DATE: September 21, 2021

SEQUIM-DUNGENESS WAY & WOODCOCK ROAD ROUND-ABOUT, CRP# C1257

ADDENDUM NO. TWO (2)

Sheet
3
of 3

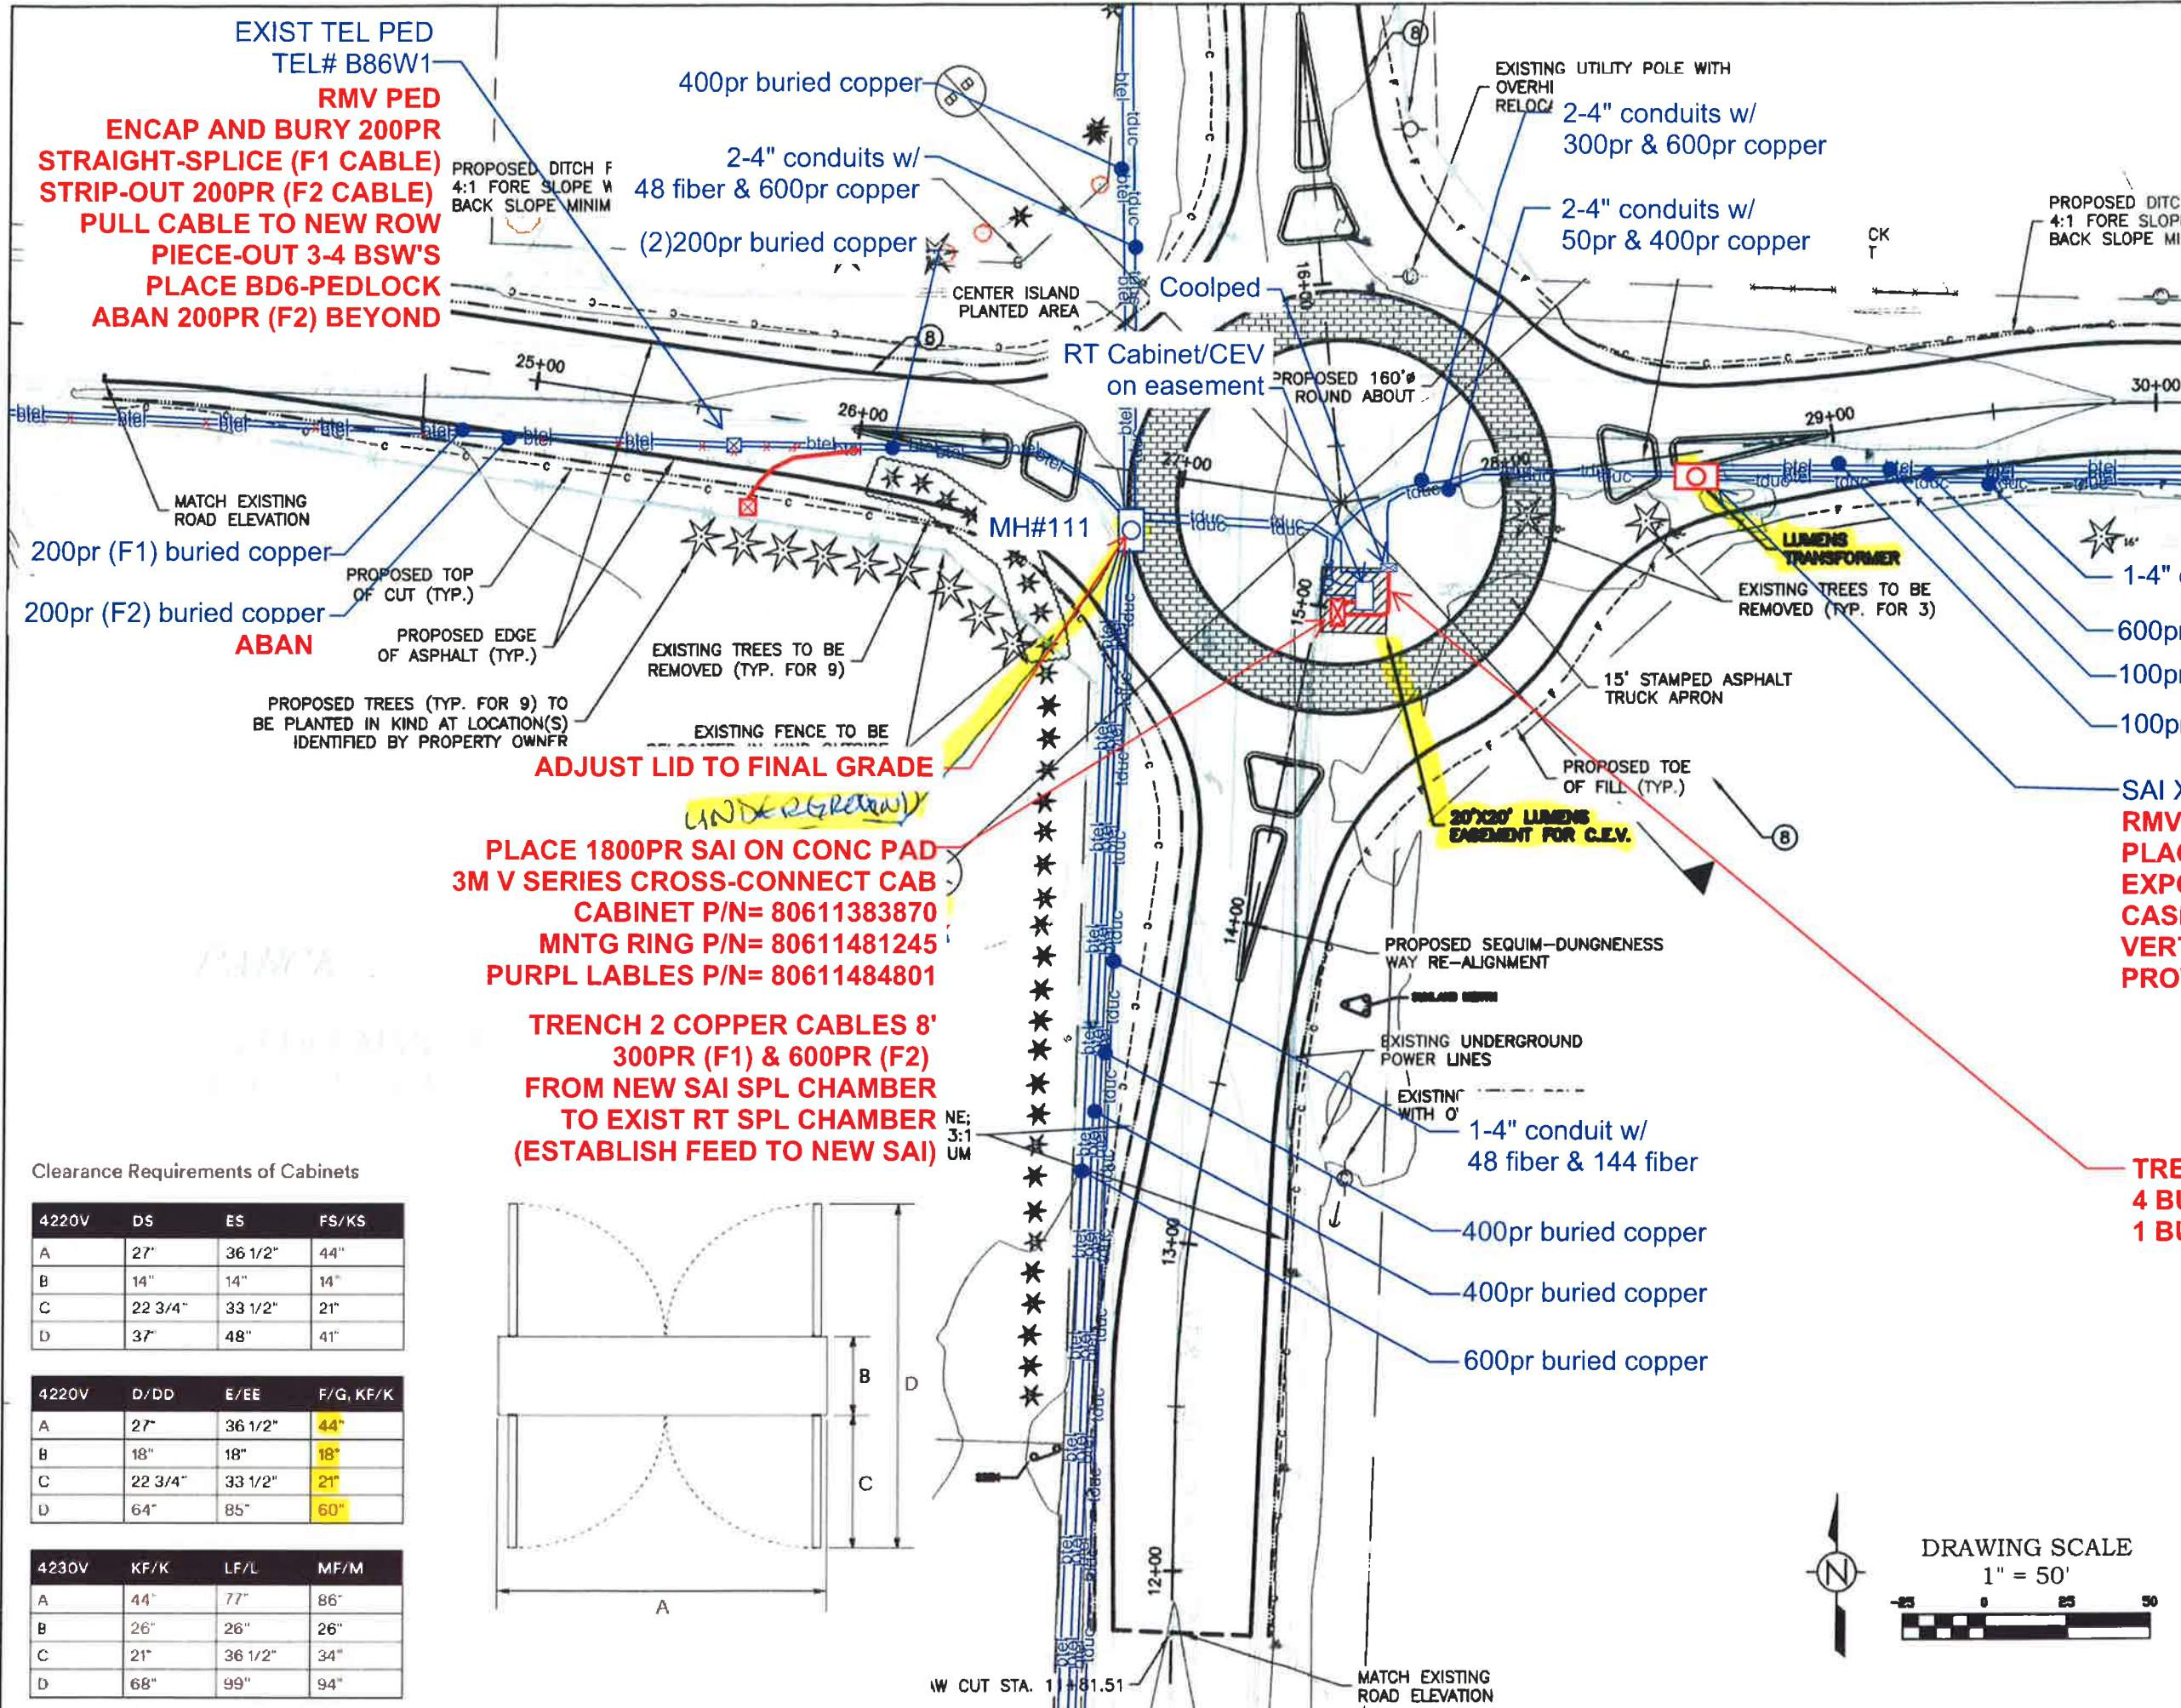
See attached Terra Technologies plan set (3 sheets dated 06/11/21) for Lumen relocation of utilities. All work will be done by Lumen contractors only. The provided plans are information only. Relocation work will occur during construction of the County road project. Coordination of work with the Lumen contractor will be the responsibility of the contractor awarded the County contract.
